# PELI NEWS

**PRODUCT UPDATE** from Peli Products (UK) Ltd  
September 2008

**TITLE: Peli Micro Case™ Design Changes**

**PRODUCTS AFFECTED: Peli's 1010, 1020, 1030, 1040, 1050, 1060 Micro Cases and i1010 Case**

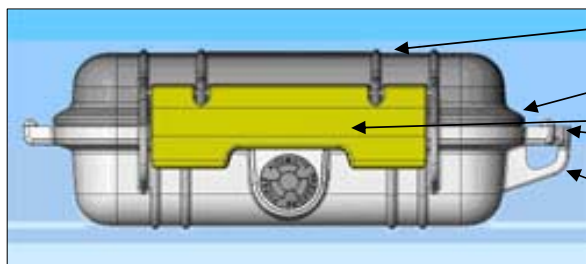
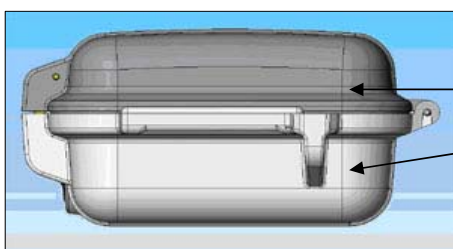
- Logo moved to middle of case
- Strap ribs reconfigured
- Corner bumpers removed
- Hinges changed for molding
- Added strap rib to opposite side

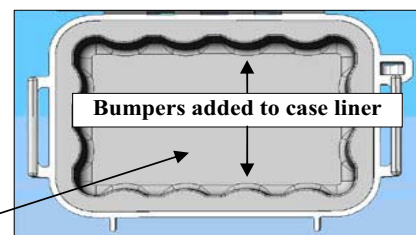
- Narrower ribs
- Lid band thickness reduced
- Strap rib profile reduced
- Loop changed from lanyard to carabiner style
- Smaller latch on 1020 and 1060

- Strap ribs on lid removed
- Carabiner loop
- Internal dimension decreased by length 3 mm and width 3 mm

- Bumpers added to case liner
